Models Affected:

TECHNICAL BULLETIN #34

December 16, 2003

Antidisturbance Filter

P/N L201 Electromagnetic Compatibility Filter, 470N+100R

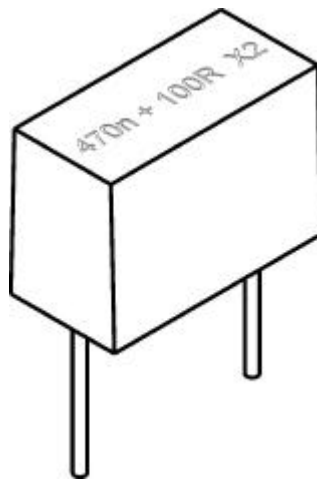
La Marzocco has discovered that in certain installations, the La Marzocco espresso machine can create electrical disturbance in the radio frequency bandwidth. This may be resolved by adding a capacitance/resistance anti-disturbance filter (p/n L201 Electromagnetic Compatibility Filter, 470N+100R). The filter must be installed in parallel with the coil of the contactor switching the steam boiler heating element. This can be accomplished either by installing the filter directly on the contactor or by installing the filter on the main electrical terminal block.
